Community Consultation and Feedback Report

This report provides an overview of the community consultation for the proposed concept design of the Arthur Highway – Eaglehawk Neck Road Widening project. The report summarises the issues raised by community members and stakeholders during the consultation activities for this phase.

Arthur Highway - Eaglehawk Neck

Road Widening - Option I

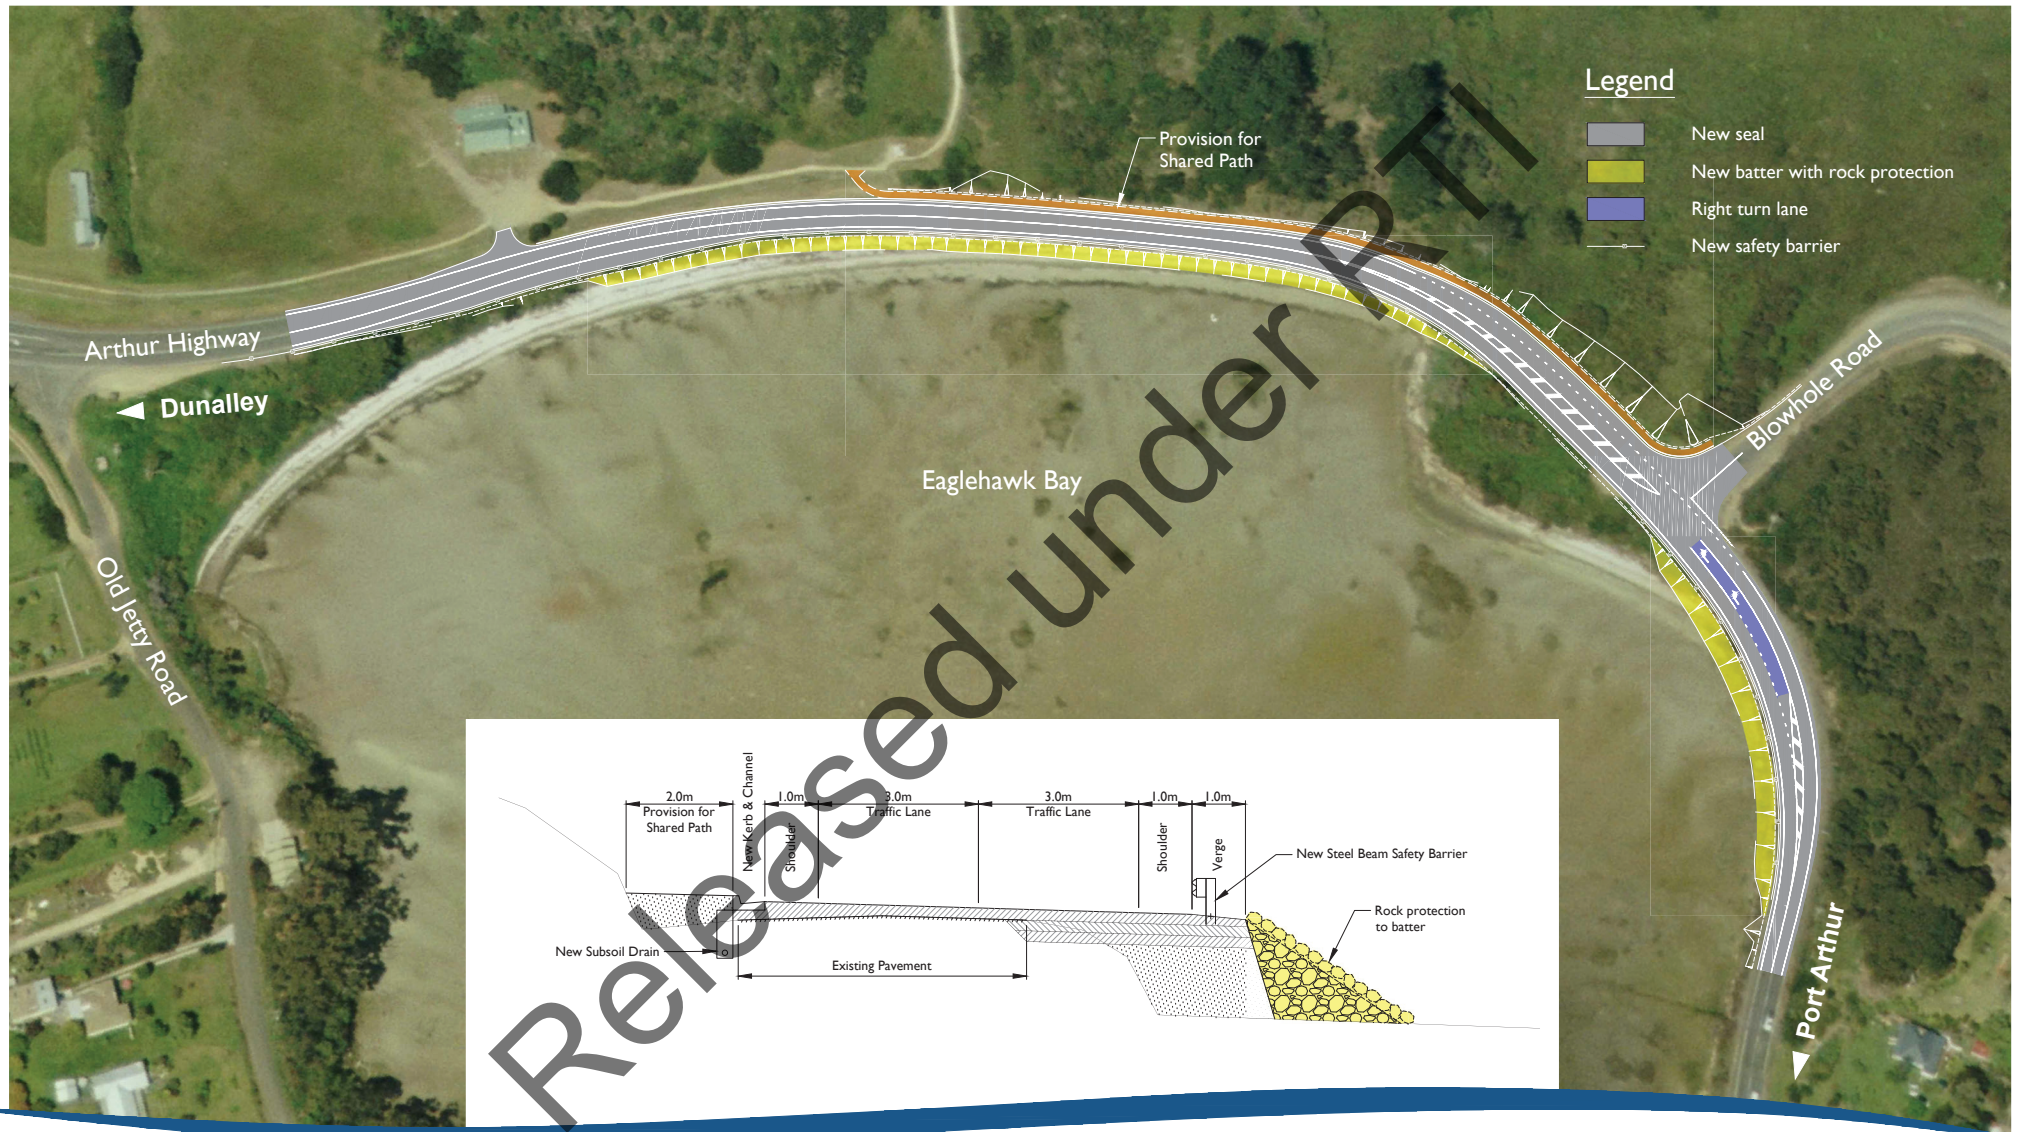
- They would like some sort of physical separation between the pathway and the road for the on-road pathway option. The kerb and channel design presented in the concept design option for consideration was seen as inadequate in terms of a safe separation between pedestrians and vehicles.

- The guard rail shown on the concept design plans should not prevent access to Eaglehawk Neck Bay.
- They would like the flooding issue around the community hall area to be addressed and remedied as the walkway from the Officers Mess to the Community Hall floods in winter or heavy rain events and is sometimes impassable.

- They were concerned about the aesthetic appearance of the proposed sea wall and guard rail shown in the concept design.
- They were concerned about what would happen to the brick fragments in the bay during construction.

Feedback	State Growth response
Physical separation between the on-road path and the southbound lane.	A safety barrier system will be installed between the shared path and highway.
Parking adjacent the Dog Line Memorial is unsafe for road users and pedestrians	'No stopping' signage has been included in the design. The enforcement of traffic rules is the responsibility of Tasmania Police.
Pedestrian, vehicular access and parking at Eaglehawk Neck Bay beach	A safety barrier will be erected along the length of the road widening works for safety reasons. Pedestrian traffic access to the beach can be obtained via the existing pathway behind the bus stop to the beach, or via the existing unformed vehicle access opposite Blowhole Road.
No pedestrian crossing facilities across Arthur Highway from Old Jetty Road.	A pedestrian crossing in the form of a traffic island will be provided across Arthur Highway from Old Jetty Road.

Road Widening - Option 2

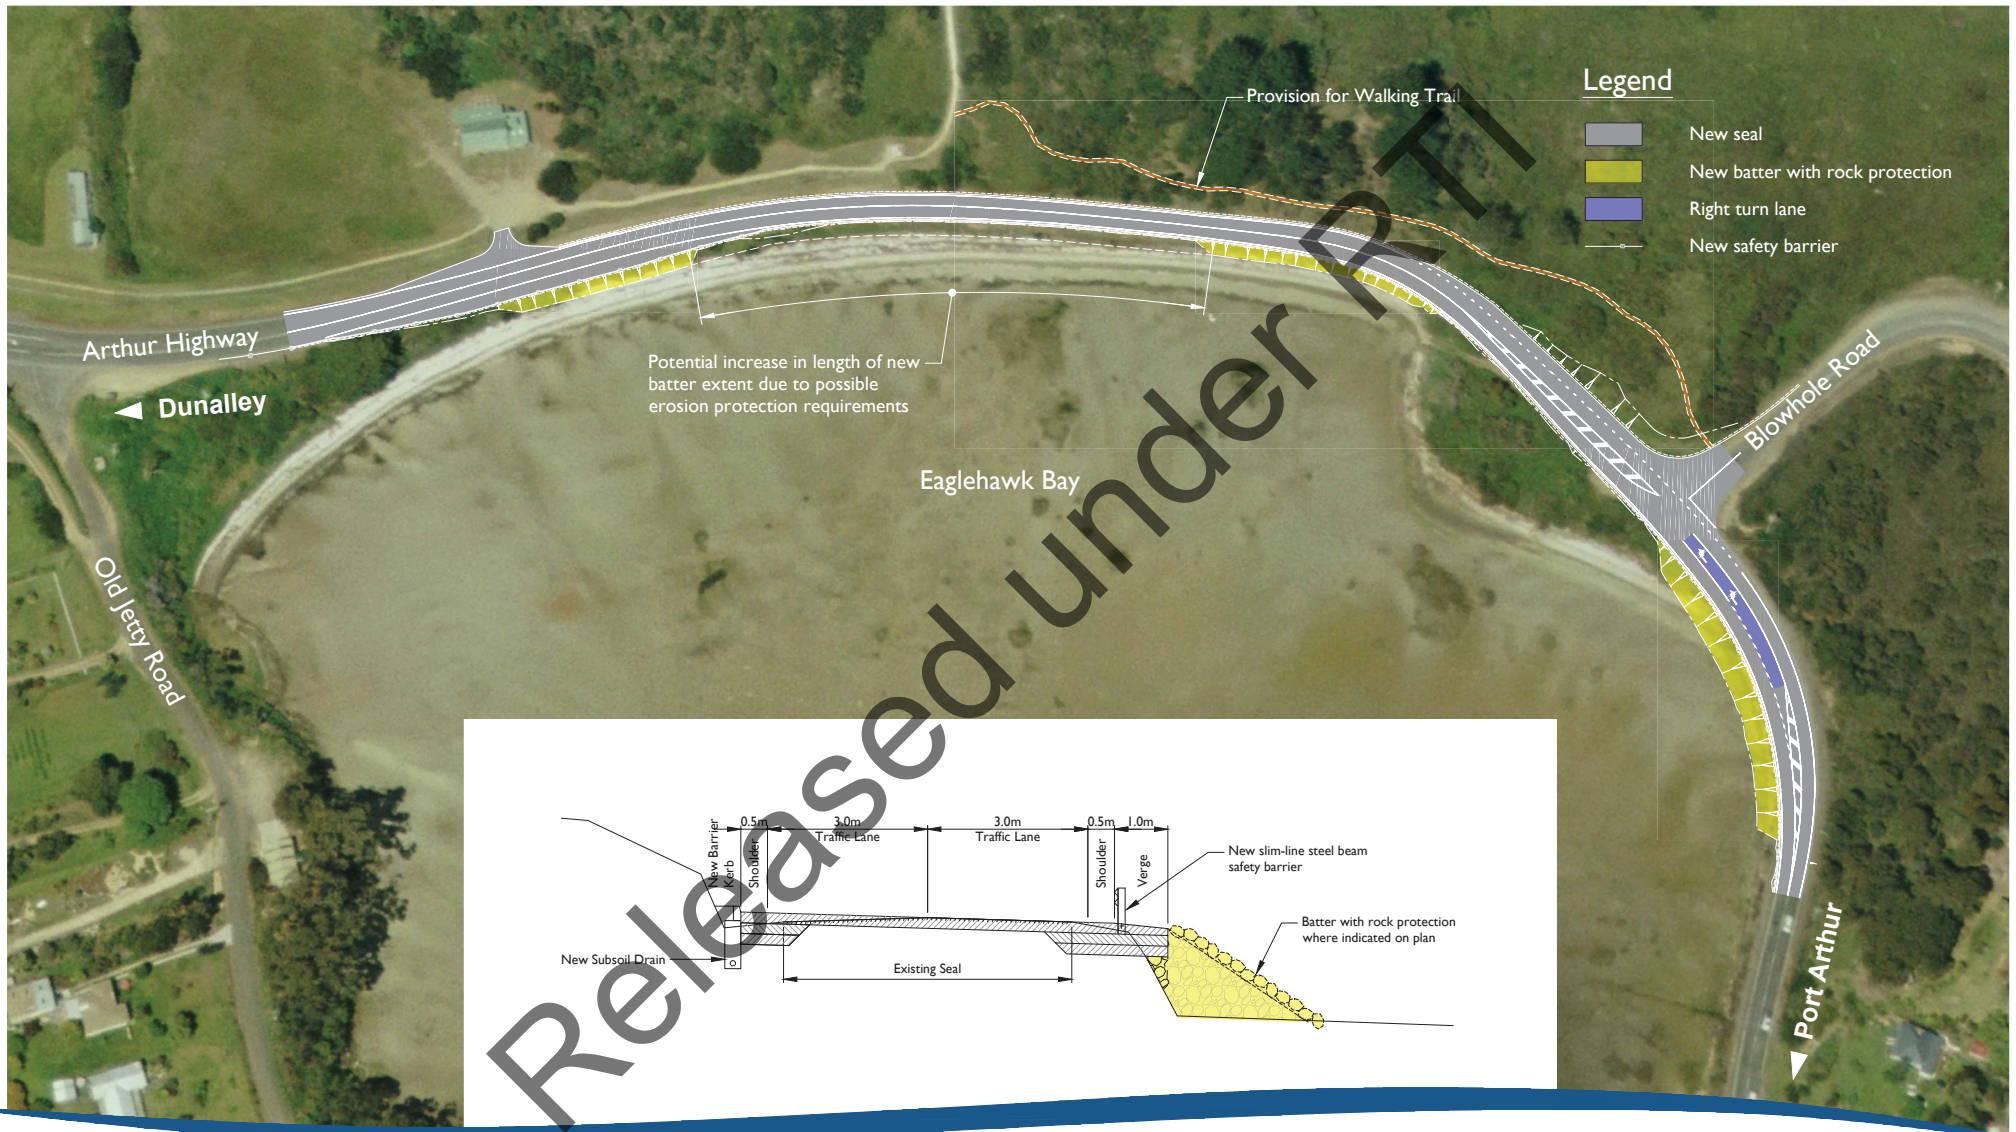
- Generally, they are very supportive of the road widening project and of the improvements to the Blowhole Road junction.
- An off-road pathway option would allow the community and visitors to enjoy the natural environment

Feedback	State Growth response
Support for improvements to the Blowhole Road junction	State Growth has included a left and right turn facility into Blowhole Road from Arthur Highway, to improve safety at this junction.
Support for provision of an off-road path	<p>At the Public Display for the <i>Arthur Highway Eaglehawk Neck – Road Widening Project</i>, two pathway options between the Dog Line Memorial and Blowhole Road were presented. The first option included the provision of a roadside pathway alongside the Arthur Highway, while the second option included the provision of an off-road pathway through the dunes.</p> <p>Although the off-road option was originally considered to better align with the community group-led project for a pathway between the Tessellated Pavements and Tasman Arch, following consideration of feedback received from key stakeholders, residents, road users, and community groups, this option has been removed from the project</p>

The feedback obtained from stakeholders and the community was used to inform aspects of the Preliminary Design. The off-road option was originally considered to accommodate a community group-led project for a pathway between the Tessellated Pavement car park and the Tasman Arch (refer to Appendix A, Option 2). This option was removed based on consideration of feedback received from key stakeholders, residents, road users, and community groups.

Arthur Highway - Eaglehawk Neck May 2020

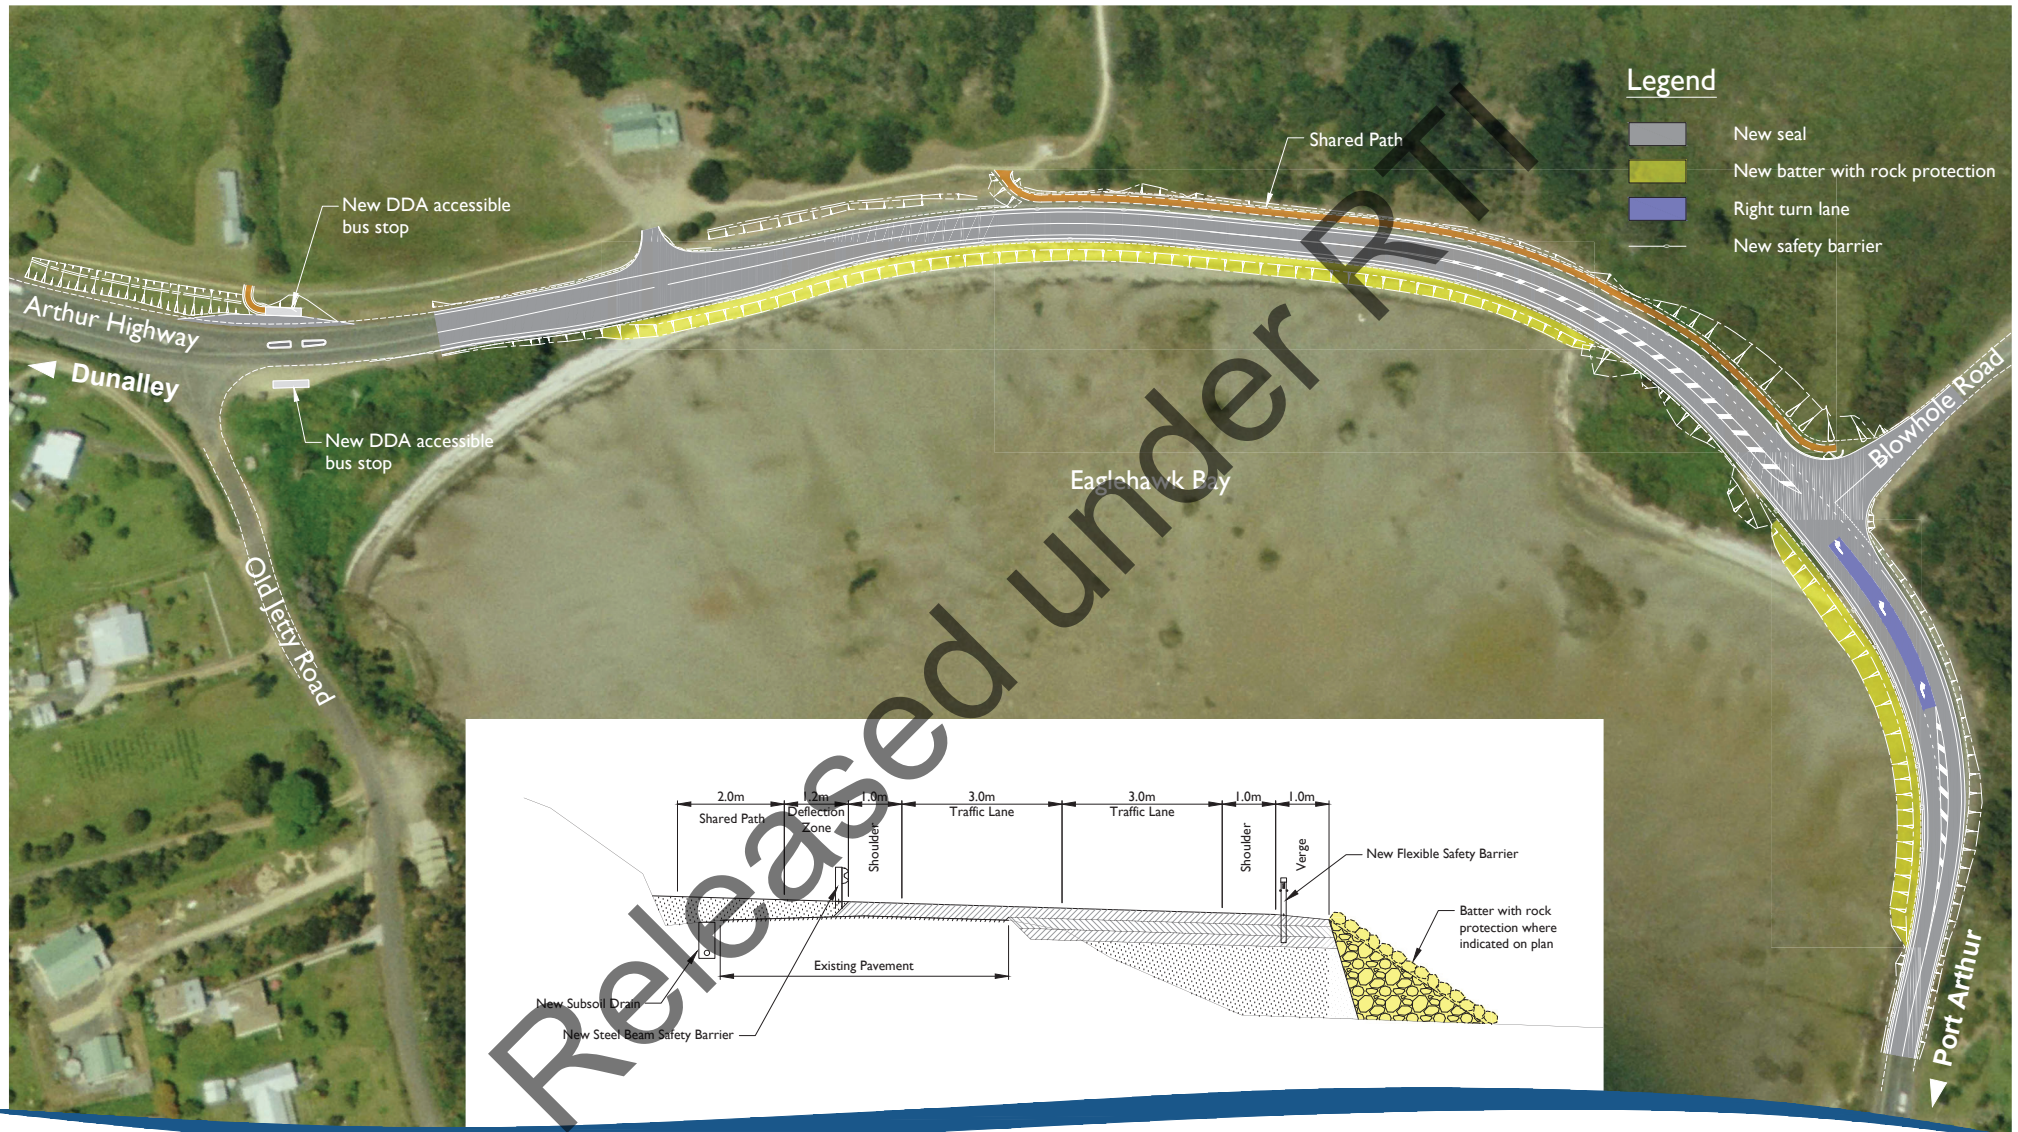
- There is concern about pedestrian safety between Eaglehawk Neck Bay and Blowhole Road.
- A pedestrian crossing facility across the Arthur Highway at Old Jetty Road would enable children and dog walkers to cross the road more safely.

The Preliminary Design layout has been included in Appendix B. This shows how some of the stakeholder and community feedback was incorporated into the design, for example, the inclusion of a pedestrian crossing point at Old Jetty Road and DDA complaint bus stops.
